Docket Item # 8 & # 9
BAR CASE # 2017-00432 &
2017-00433

BAR Meeting
April 4, 2018

ISSUE: Partial Demolition/Capsulation & Alterations

LOCATION: 926 South St. Asaph Street

Figure 3: Aerial map showing the public alley (in red) and a blue arrow pointing to the townhouse

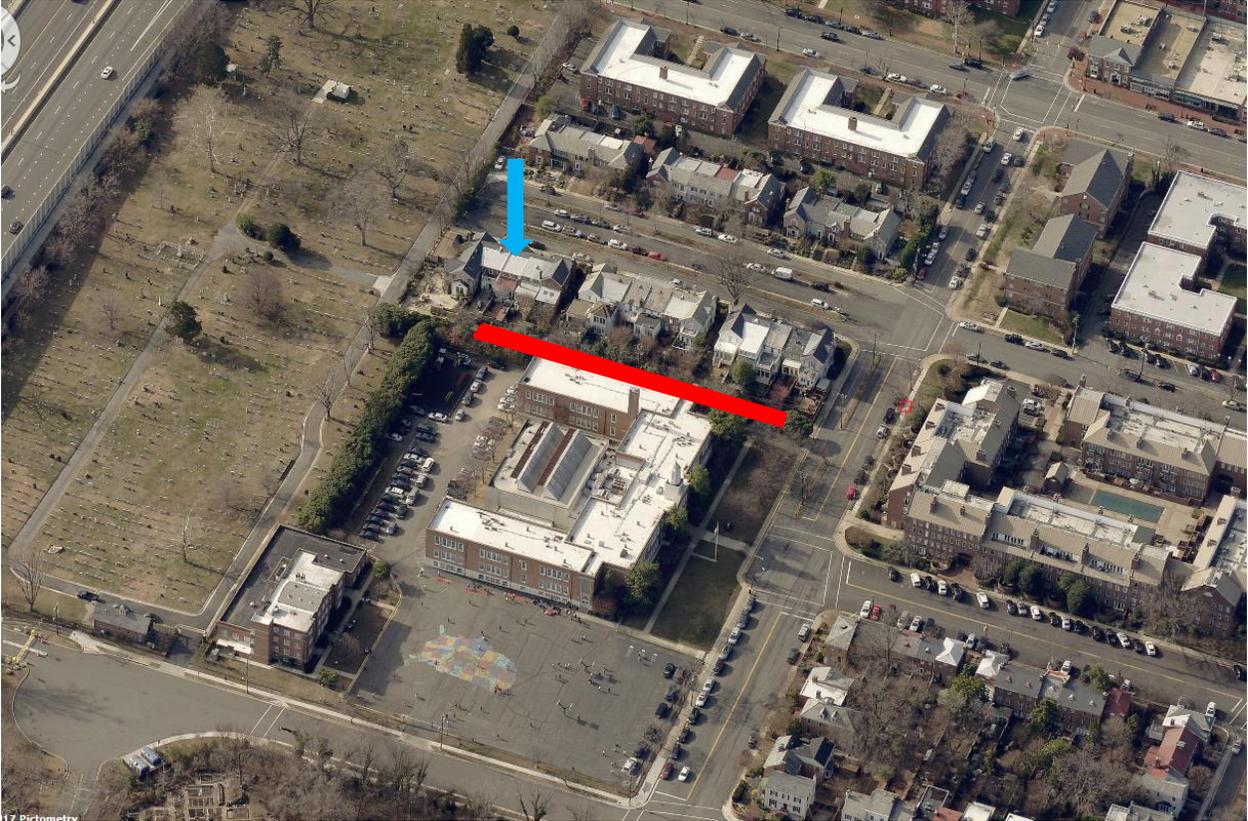
Although the proposed addition is lacking in detail, as staff noted previously the rear of the original masonry townhouse also lacks detail and there are no lintels over the existing windows or door. Therefore, staff finds the proposed addition to be compatible with the secondary elevation of the original dwelling. In addition, the rear of this townhouse is only visible from a dead-end public alley, looking over the 6 foot tall rear yard fence (Figure 2). The opposite side of the alley abuts a large private parking lot behind a private school (Figure 3).

MAIN FLOOR LAYOUT

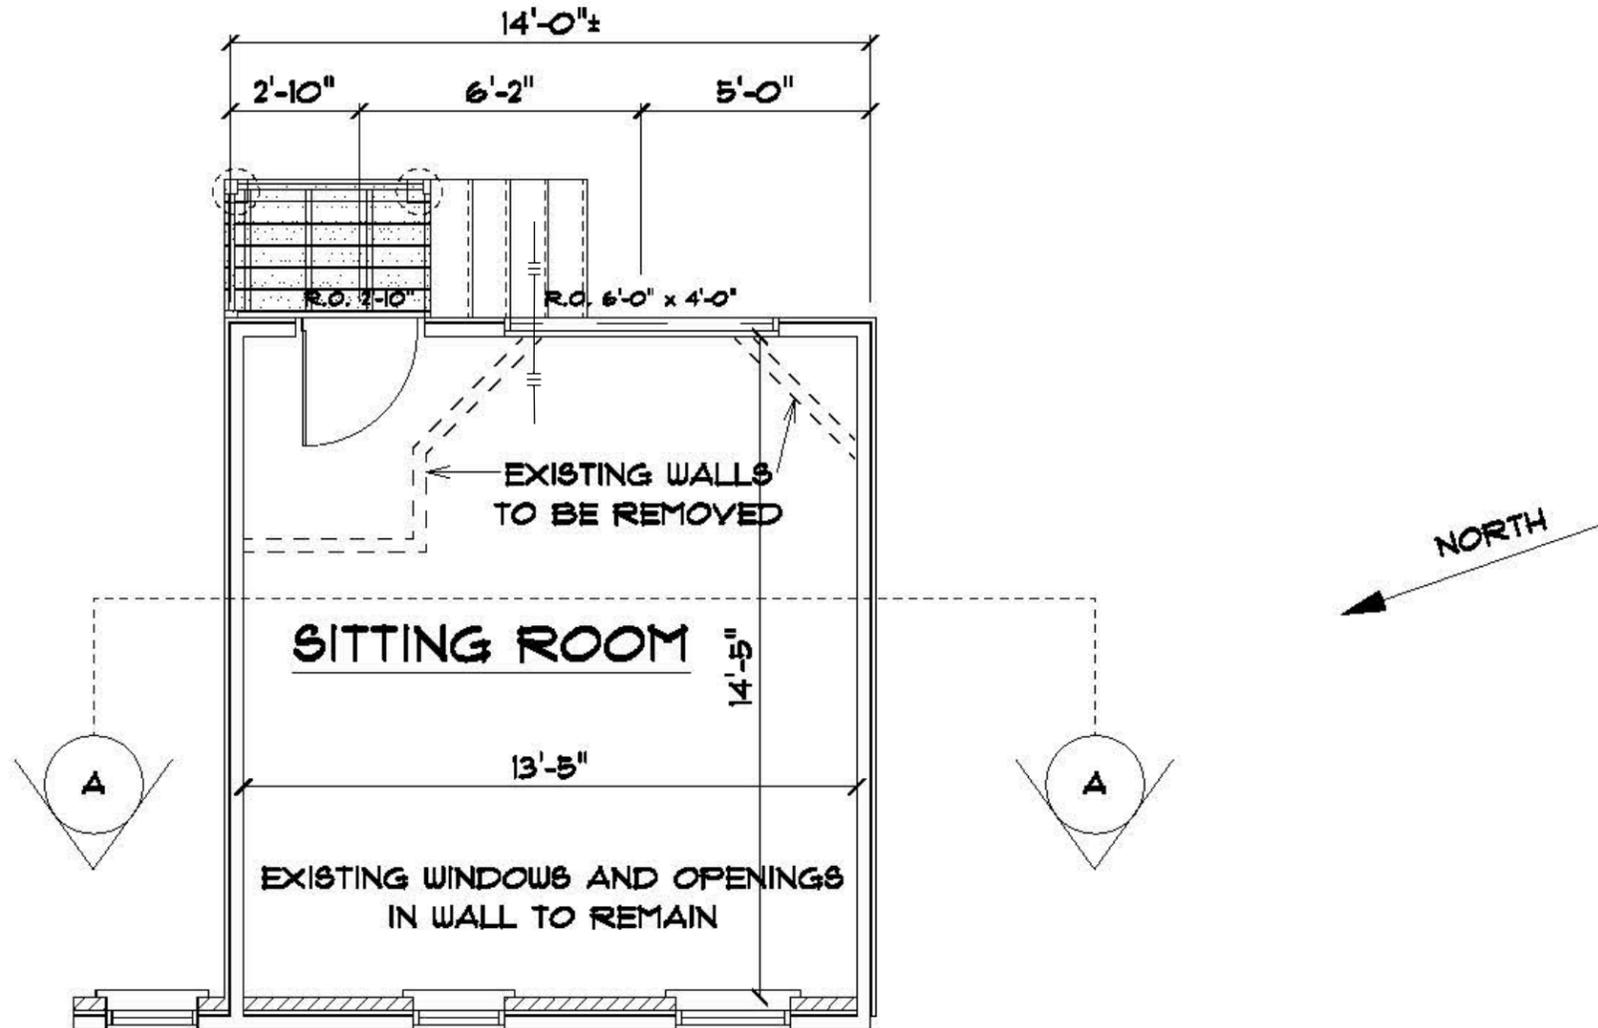
Staff has no objection to the use of smooth fiber cement clapboard siding, the Anderson Fibrex windows or the steel door, as these materials comply with the BAR's adopted policies for modern additions, so long as they comply with the BAR's adopted policy for glass transparency and SDL muntins. The applicant must submit detailed window and door specifications with the building permit in order for staff to confirm full compliance with the policy.

1. The door and windows shall fully comply with the BAR's adopted policies for new construction for glass transparency and muntins; and,
2. The archaeology conditions below shall appear in the General Notes of all site plans and on all construction documents that involve demolition or ground disturbance (including Basement/Foundation Plans, Demolition, Erosion and Sediment Control, Grading, Landscaping, Utilities, and Sheeting and Shoring) so that on-site contractors are aware of the requirements:

REAR ELEVATION

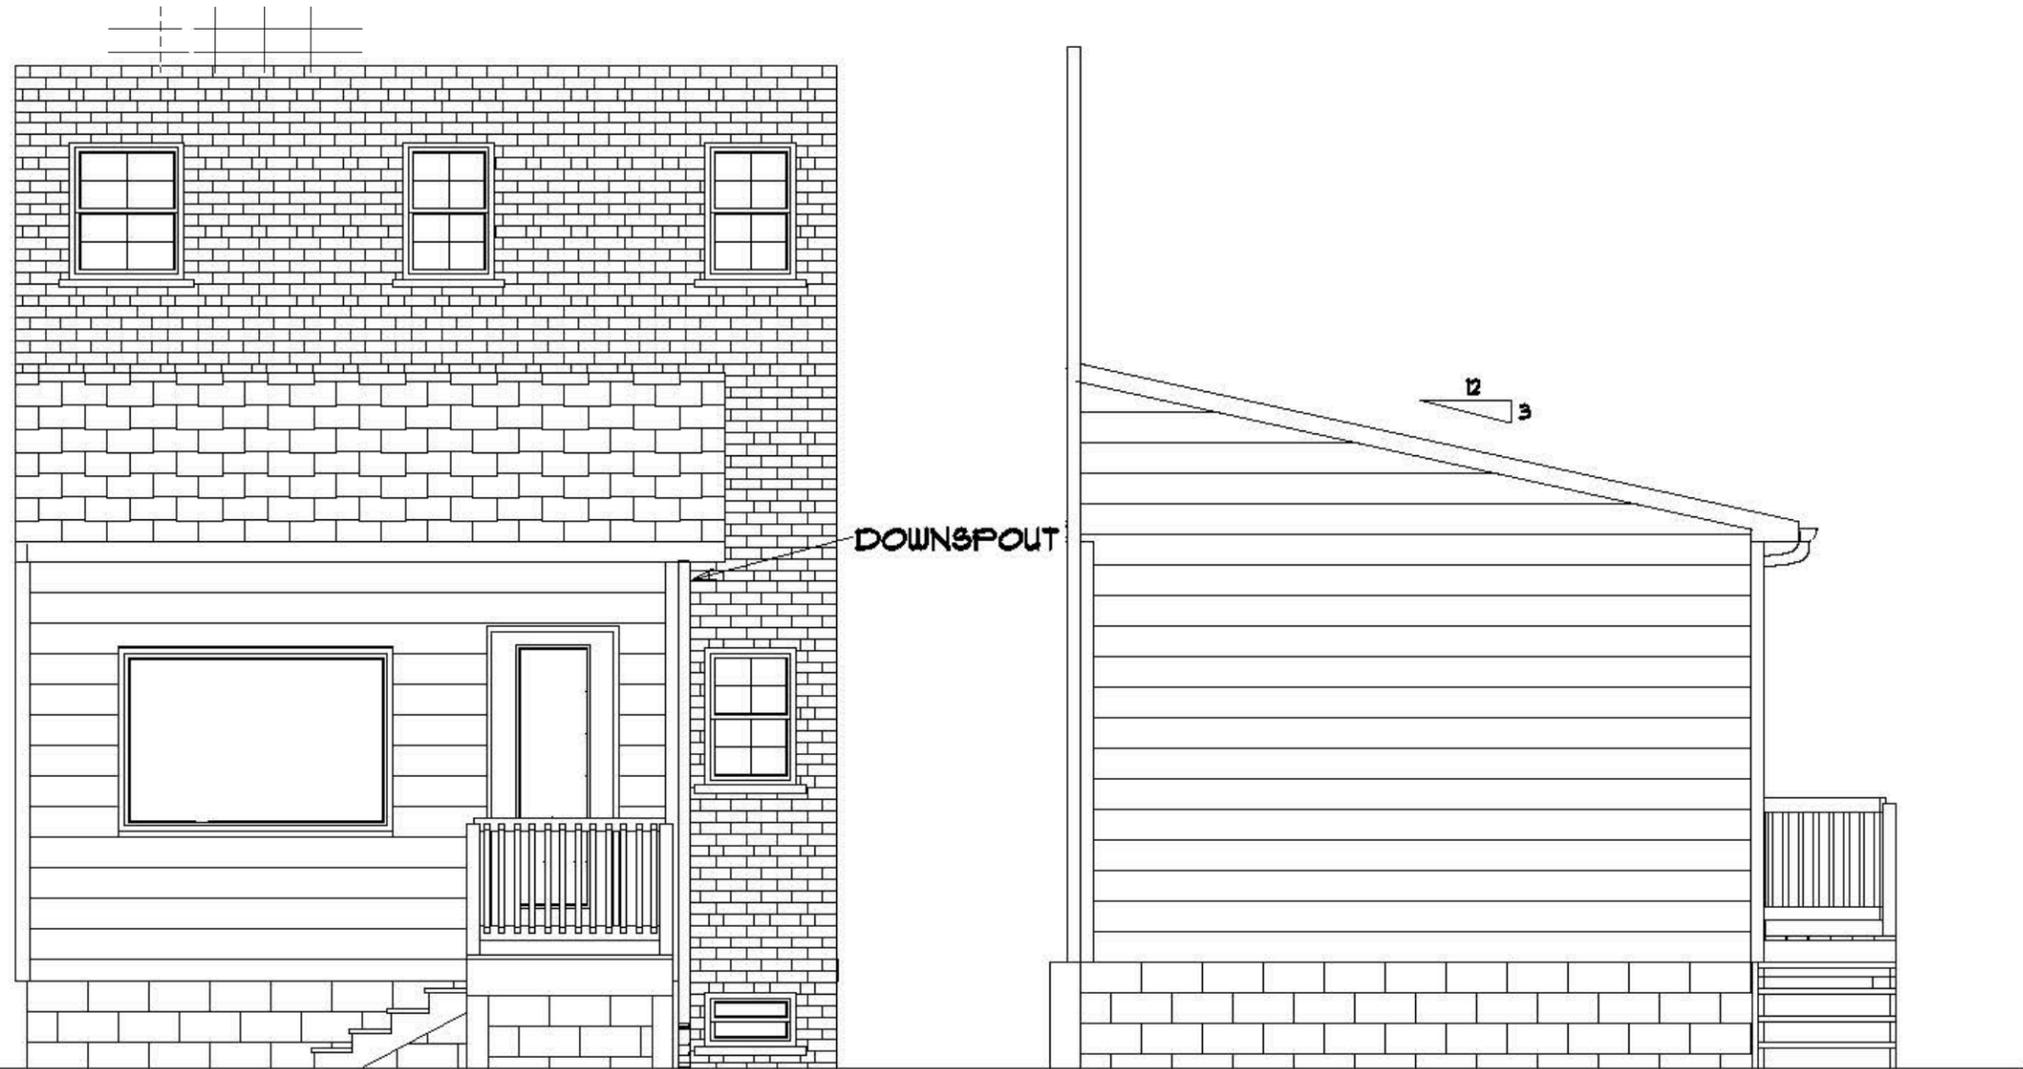
Since the project was deferred for restudy at the December 20, 2017 BAR hearing, the proposed roof form was changed from a gable to a shed roof so that all run-off will occur on the applicant's property. The application materials were also updated for consistency.

While staff finds the form of the existing rear addition to be more visually interesting than the proposed utilitarian rectangular plan that is lacking in architectural detail, the addition is consistent with the unadorned historic rear elevation of this townhouse and the BAR's *Design Guideline for Residential Additions*, which recommends: "...a distinct yet compatible contrast with the original building through the use of differing materials, colors and the abstraction of the principal design elements of the original elements."
